FIELD ENGINEERING BILL-4520644 EC LEVEL- 857061 LOC-GREN

MACHINE TYPE-3614-001, 3614-002, 3614-011, 3614-012,

TITLE- INS FFBM VER 5 (DES DC9001) ON VER.3 MACHINES WITH TLA
FC 7820

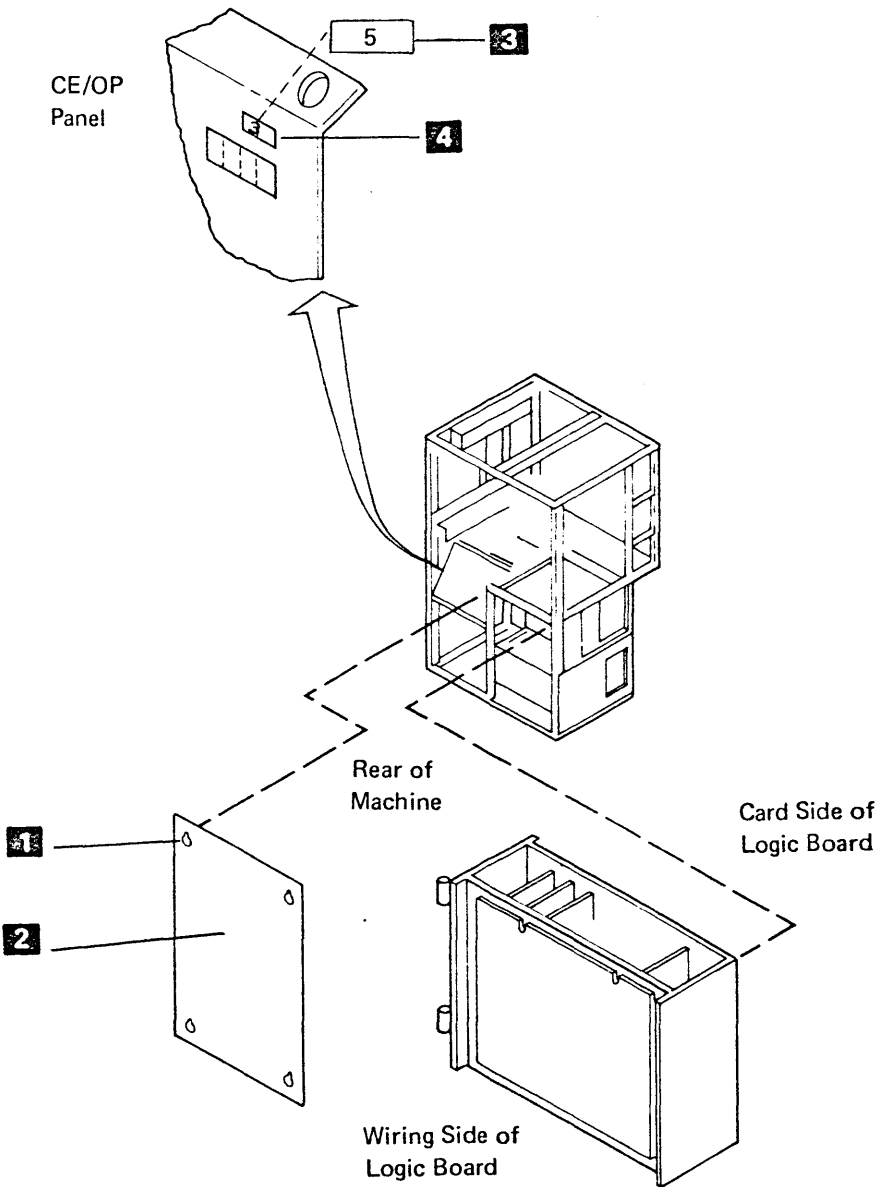
- 4. Remove Version 3 sticker 4 from upper right corner of CE/OP panel, above the display window.

- 5. Install Version 5 sticker 3 (P/N 5412746) onto upper right corner of CE/OP panel, above the display window.
- 6. Install the logic gate/power supply cover to the rear of the 3614 tightening screws loosened in step 10.1.3.
